**TOWN OF WINTER PARK
PLANNING COMMISSION**
Tuesday, January 9, 2024 8:00 AM

TO Planning Commission
FROM Hugh Bell, Planner
THROUGH James Shockey, AICP, Community Development Director
DATE January 9, 2024
RE Minor Site Plan – 148 Fir Drive – Lots 7 and 8, Winter Park Village Subdivision (PLN23-111)

Lighting Board

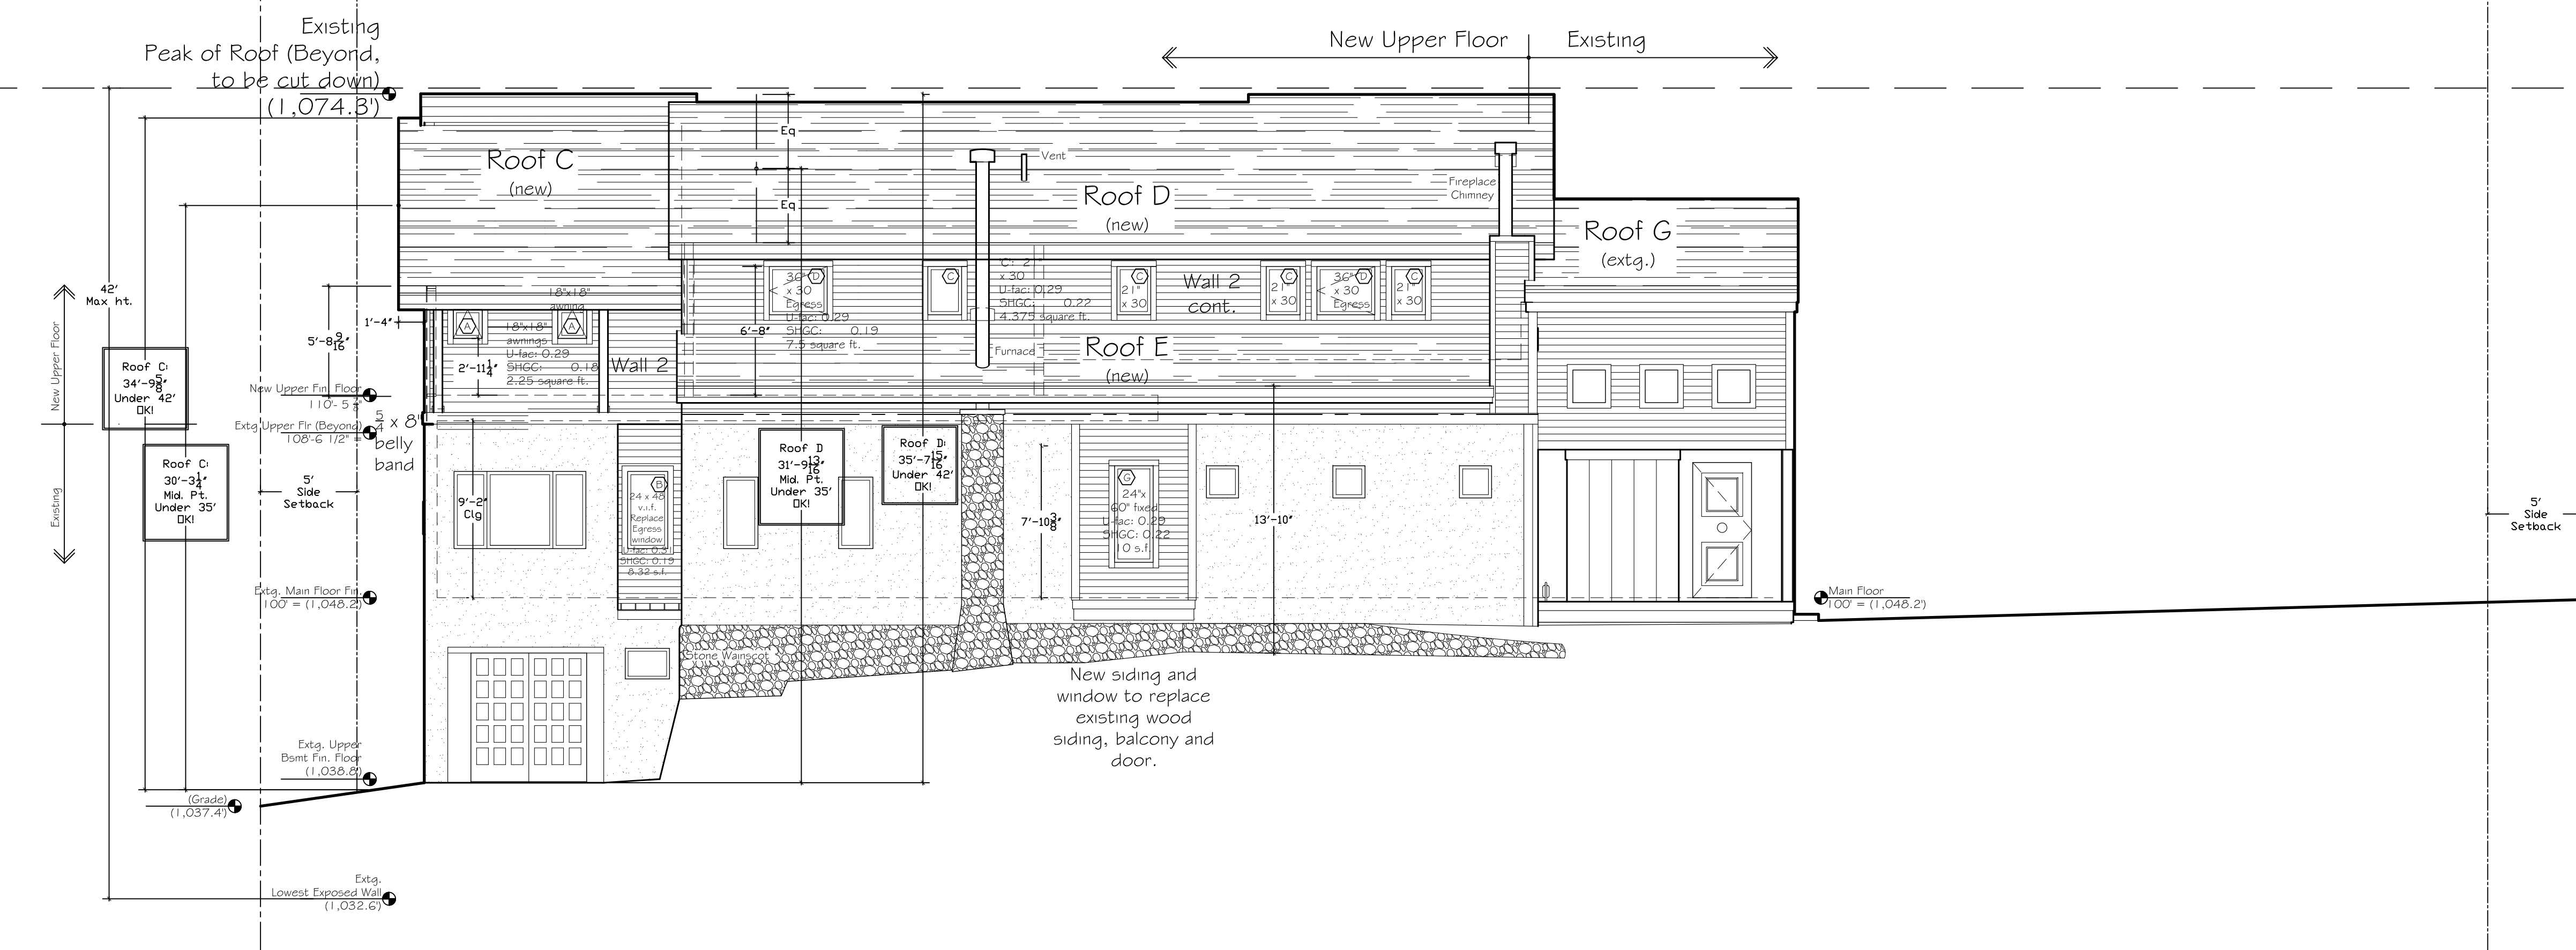
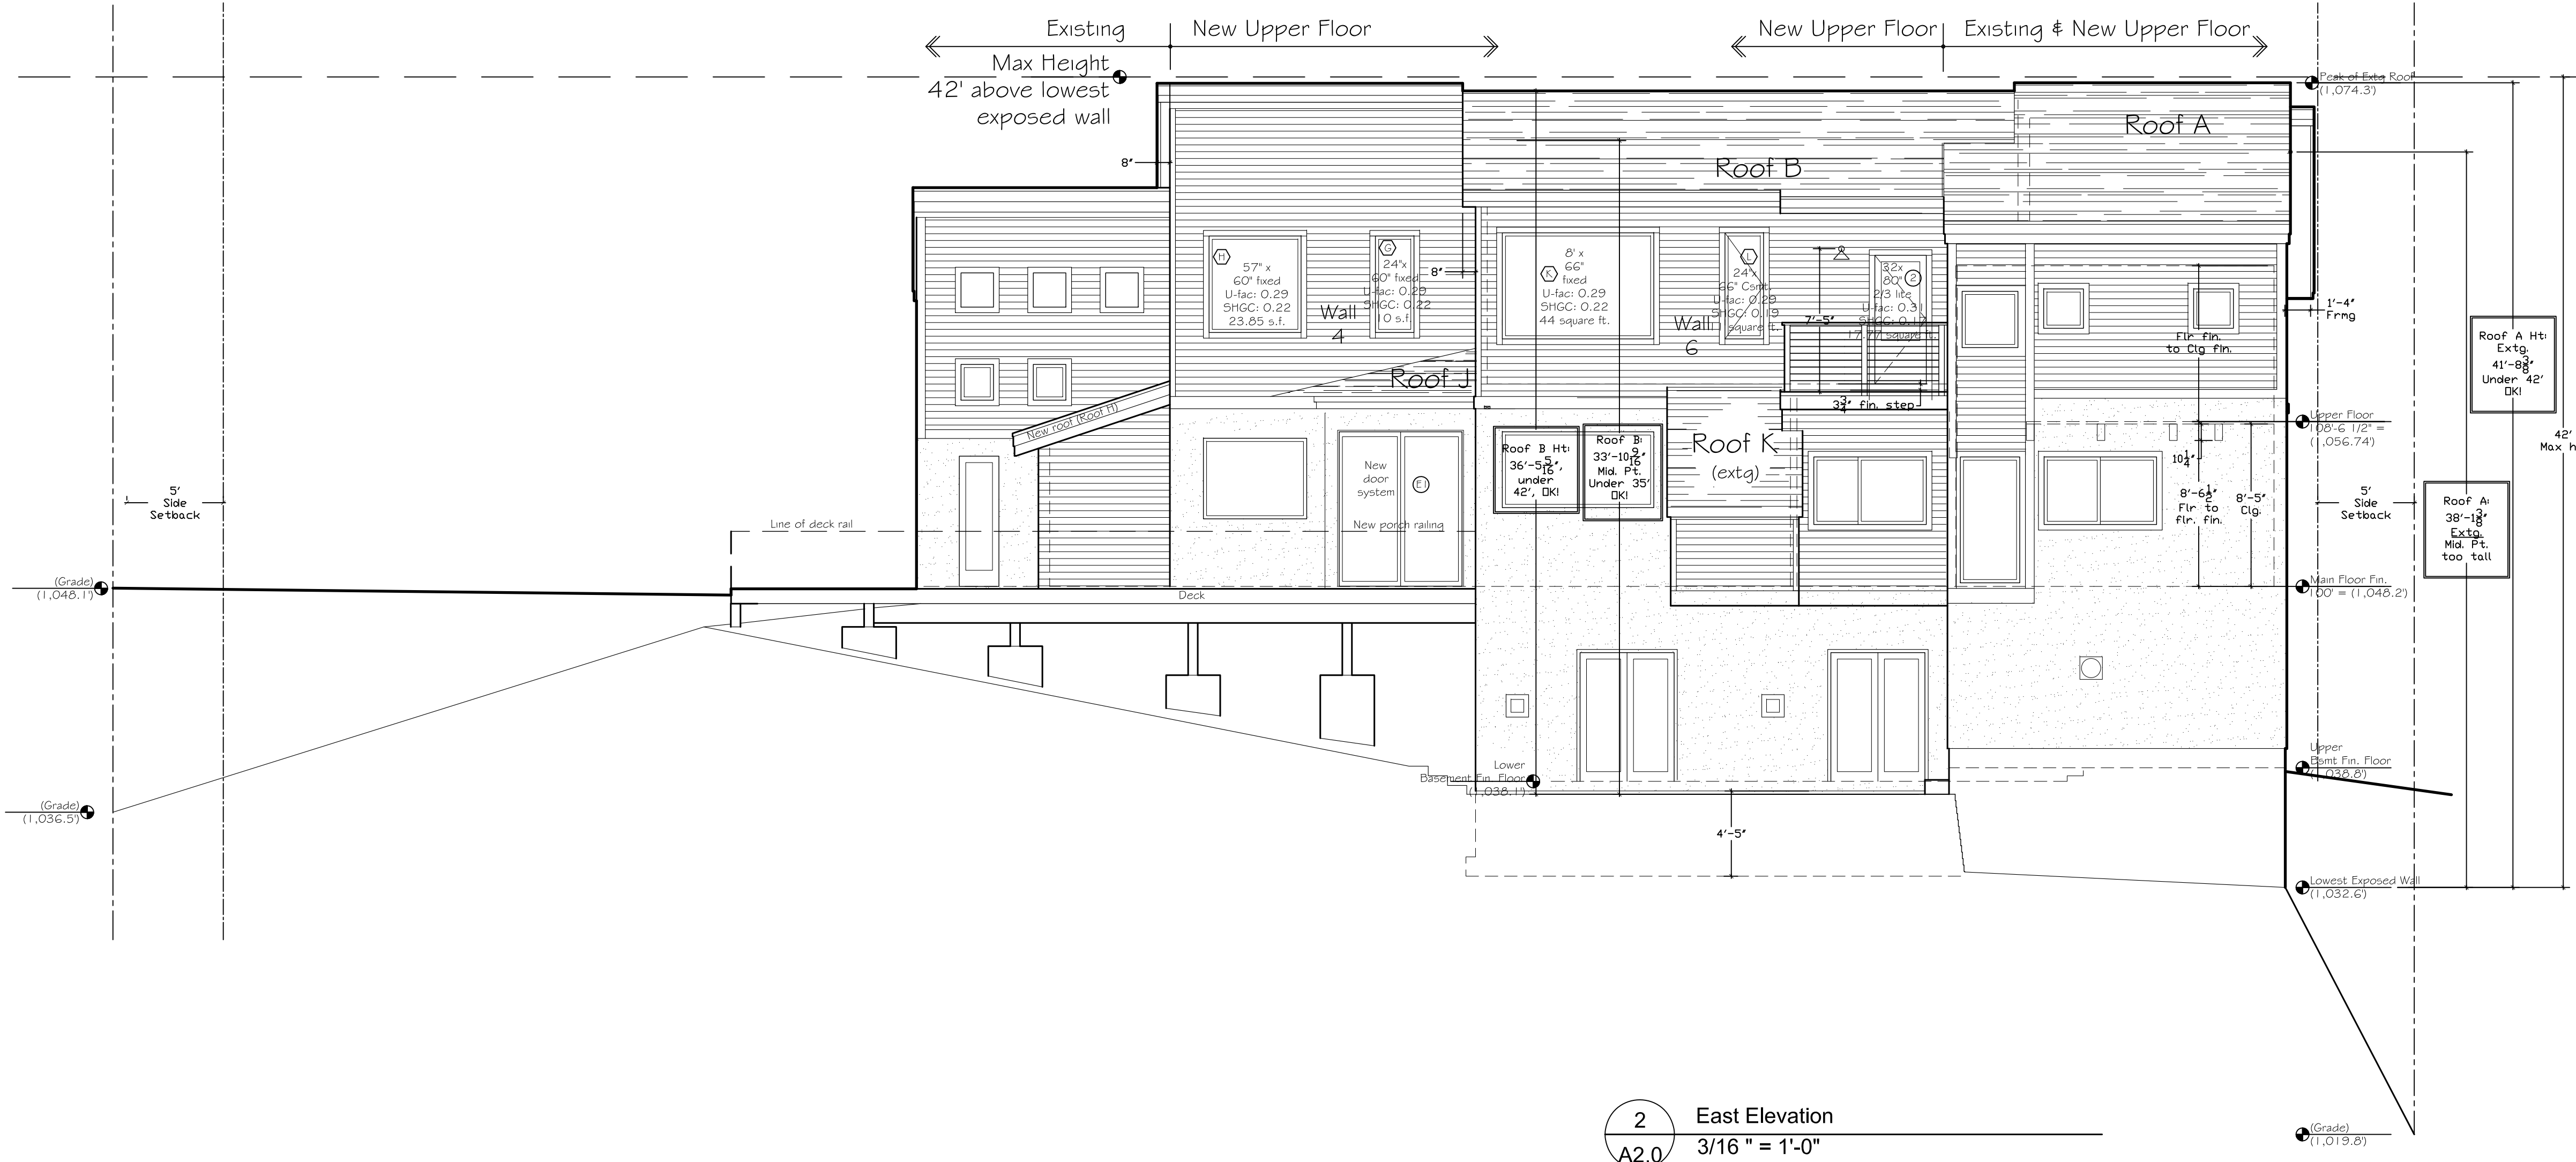
Partially satisfactory. One (1) fixture is proposed and contains the International Dark Sky Association (IDA) approval stamp (UDC, § 3-K-3(A)(1)). Single-family properties are limited to 5,100 lumens and each fixture shall not exceed 850 lumens. There are existing outdoor lighting fixtures and it is unclear if they conform with the UDC; per § 3-K-7, Existing Lighting Requirements, this project constitutes a “Major Addition” as the addition comprises more than 25% of the existing gross floor area (4,662 sqft total; 1,166 sqft is 25% and 1,510 sqft will be added), which means any existing nonconforming lighting must come into conformance.

- In accordance with Article 3.K, Outdoor Lighting, Applicant shall confirm if existing lighting fixtures conform with the UDC via photo documentation; if not, Applicant shall replace these with conforming fixtures.

1. In accordance with Article 3.K, Outdoor Lighting, Applicant shall confirm if existing lighting fixtures conform with the UDC via photo documentation; if not, Applicant shall replace these with conforming fixtures.

GRADING AND DRAINAGE PLAN

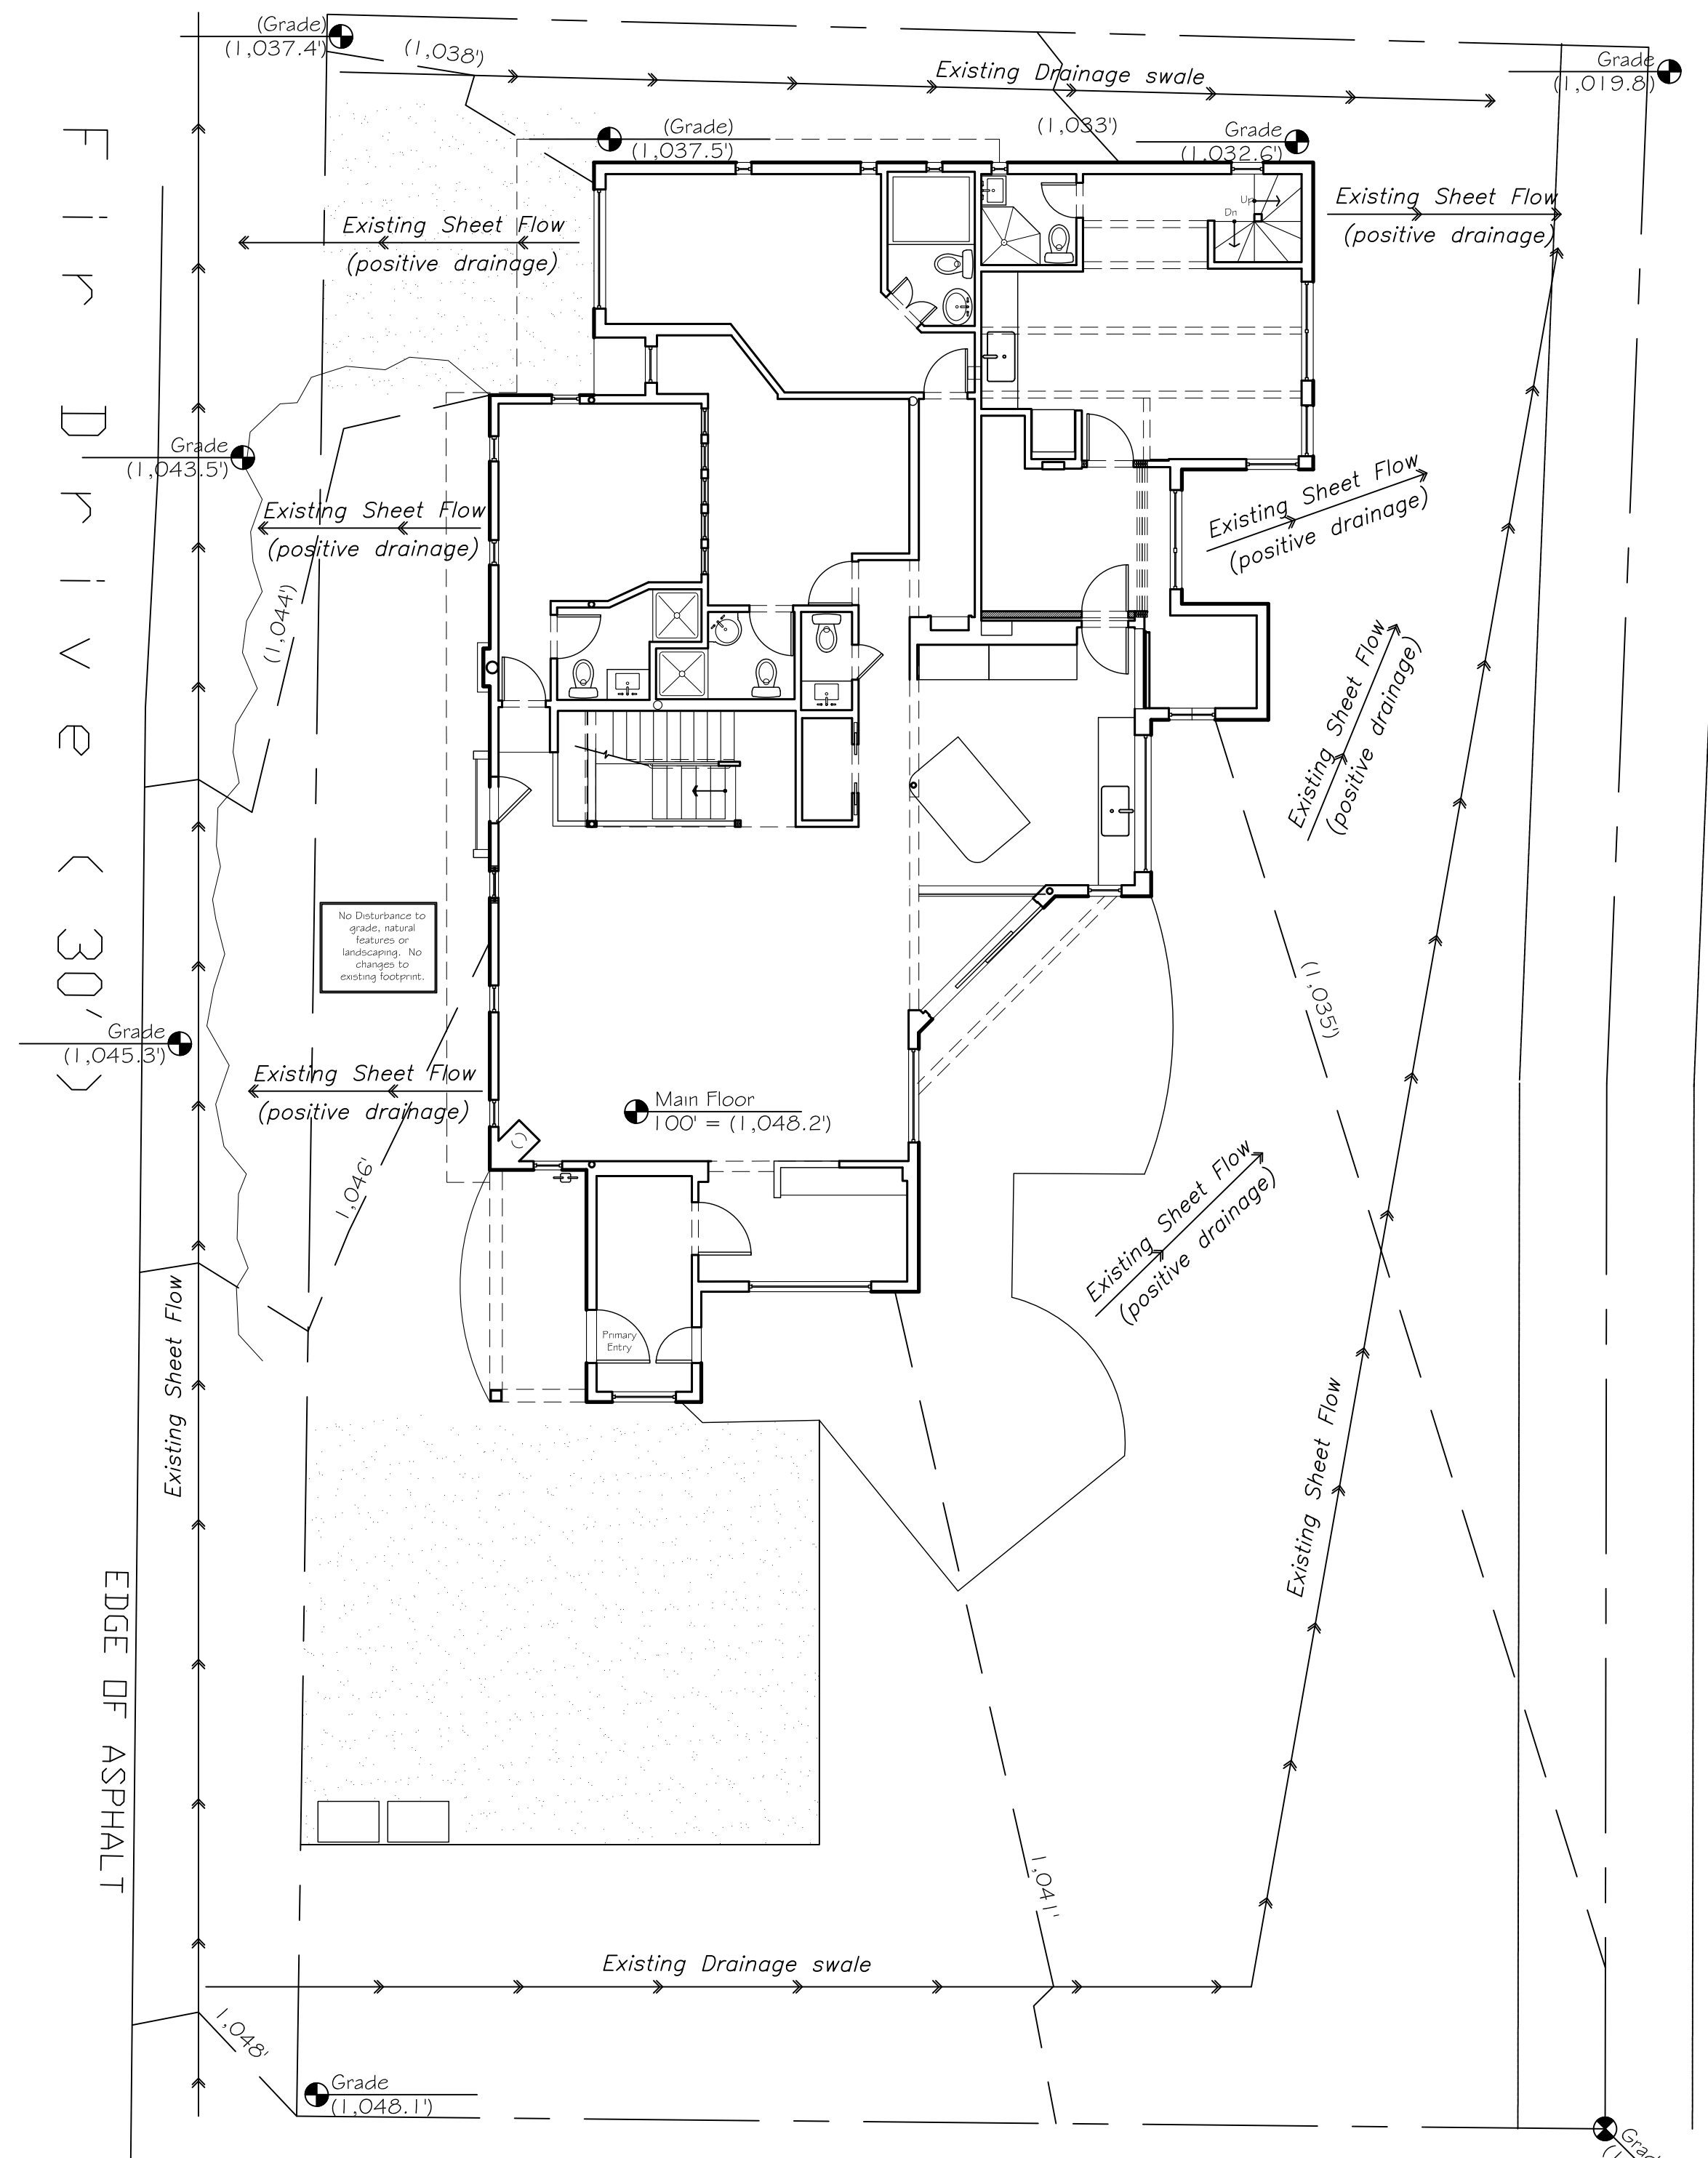
TBD. The Town Engineer is reviewing the Grading Plan and staff will forward comments when they arrive.

- Should the Town Engineer have comments, Applicant shall revise Grading Plan accordingly.
- Approved drainage and erosion control shall be in place prior to and throughout site preparation and construction and through successful revegetation.
